Agenda
Crowley Planning & Zoning Commission
September 28, 2026
Regular Session - 7:00 PM

Presenter: Bhumika Thakore, Rachel Roberts	Meeting Date: September 28, 2026
Department: Community Development	Agenda Item: III.B.
Subject: Discuss and make a recommendation to the City Council on a preliminary plat for MAA Crowley Crossings Addition, Lots 1-6X, Block 1, being approximately 8.462 acres situated in the Juan Armendaris Survey, Abstract No. 1767, City of Crowley, Tarrant County, Texas. Case # PPLT-2026-006.

City staff have reviewed the **2nd preliminary plat for MAA Crowley Crossings Addition** and have the following comments. Please include a comment response letter with your response.

To: Bhumika Thakore, Planner
From: Chris Edwards, PE; Chris Cervenka, PE, CFM
Date: September 16, 2026
RE: **MAA Crowley Crossings Addition (formerly Crowley Plover Addition)
Preliminary Civil Plans
Review #4**

PRELIMINARY PLAT
MAA CROWLEY CROSSINGS ADDITION
LOT 1, LOT 2, LOT 3, LOT 4, LOT 5 & LOT 6X, BLOCK 1
8.462 ACRES
ZONED AS GENERAL COMMERCIAL
SITUATED IN THE
JUAN ARMENDARIS SURVEY ABSTRACT NO. 1767
TARRANT COUNTY, TEXAS

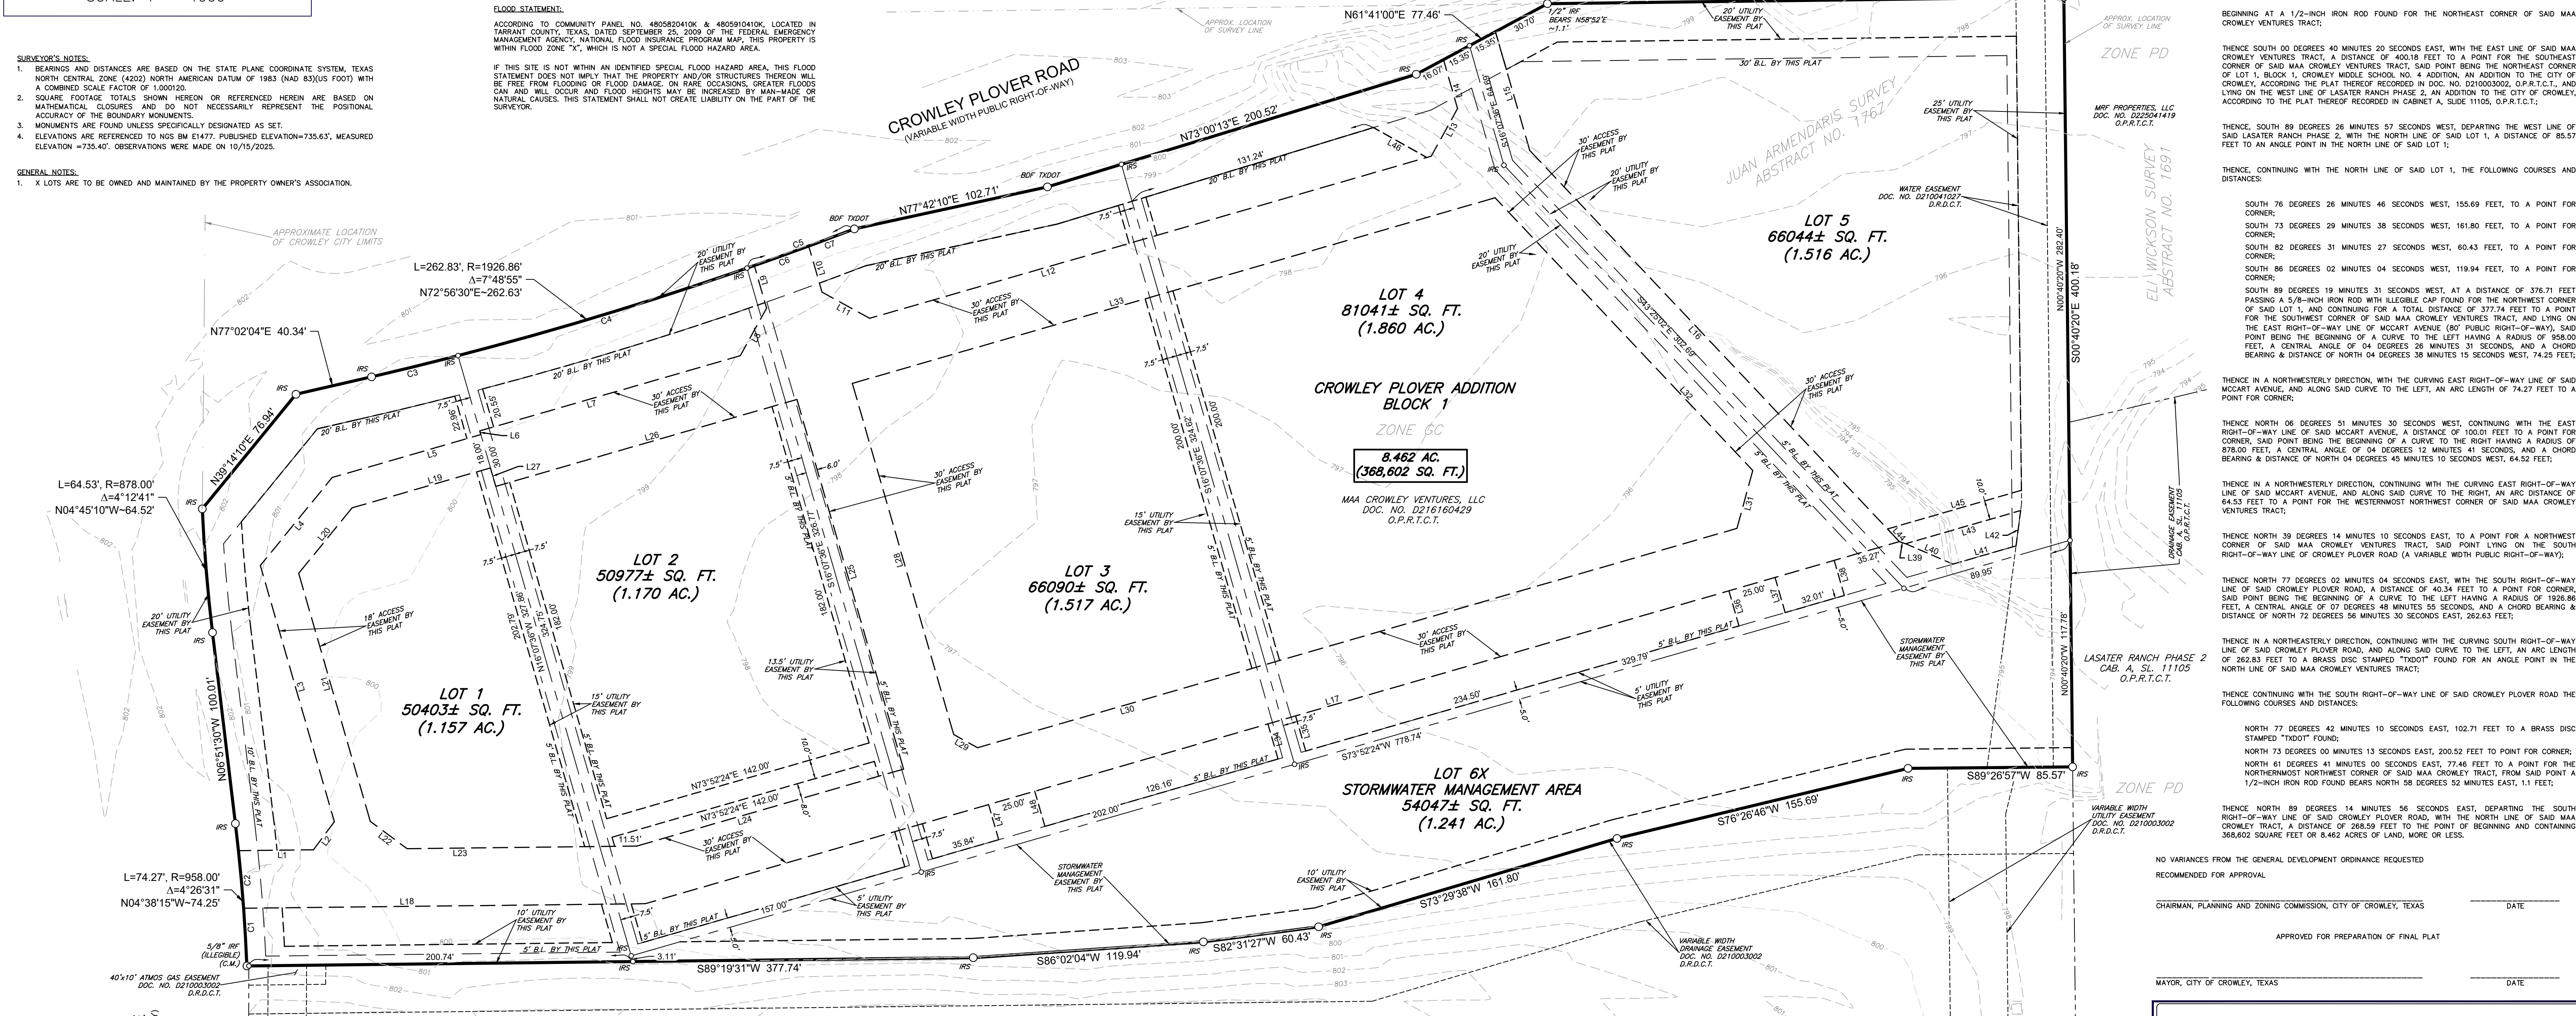
As currently submitted, the preliminary plat does not clearly delineate and label the limits of Phase 1 and future phases. Therefore, staff is unable to determine the extent of Phase 1 or whether each phase is capable of standing alone in accordance with the applicable subdivision requirements.

The engineering review identified an outstanding comment related to the proposed detention pond that remains unresolved and may affect approval of the preliminary plat. The outstanding engineering comment is as follows:

a) The updated pond calculations show a peak 100-year pond elevation of 796.65, while the top of pond is 797. Please provide at least 1-foot of freeboard in the pond above the 100-year water surface elevation.

As currently submitted, the preliminary plat does not clearly delineate and label the Phase 1 boundary and future phase lines. Because the extent of each phase is not clearly established on the preliminary plat, staff is unable to determine whether Phase 1 includes all improvements necessary to function as a stand-alone phase without relying on improvements proposed within a future phase.

Additionally, the updated detention pond calculations show a peak 100-year pond elevation of 796.65, while the top of the pond is 797. The engineering review requires at least one foot of freeboard in the pond above the 100-year water surface elevation.

1. Per Chapter 98, Sec. 98-24, Sec.98-44, and Sec. 98-50(a)(29) of the Subdivision Regulations, phase lines are required to be clearly delineated on the preliminary plat. Please revise the preliminary plat to clearly delineate and label the Phase 1 boundary and all future phase lines.
